07-09 LATEST REVISION DATE <i>Thomas C. McQuinn</i> APPROVED BY BRIDGE ENGINEER		
	STANDARD DESIGN - 40' ROADWAY, 3 SPAN BRIDGES CONTINUOUS CONCRETE SLAB BRIDGES NOVEMBER, 2006	
SUPERSTRUCTURE DETAILS ALL BRIDGES		J40-20-06

PART PLAN 0° SKEW
(RAILING NOT SHOWN)

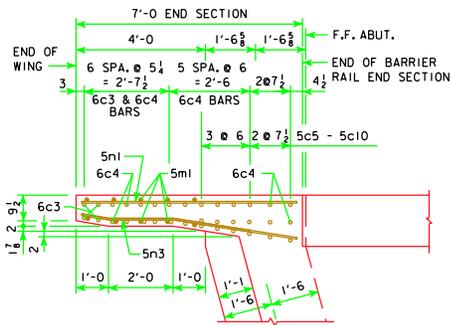
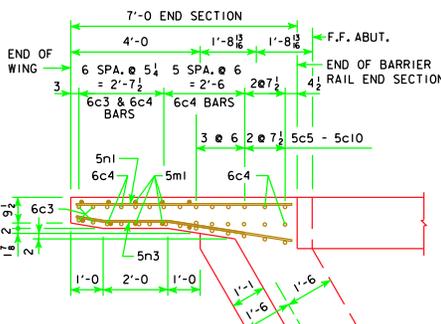
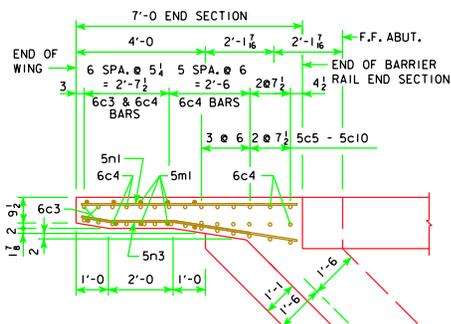
REVISED 07-09 - REPOSITIONED THE 6c4 BARRIER RAIL BARS IN THE PART PLAN VIEWS.
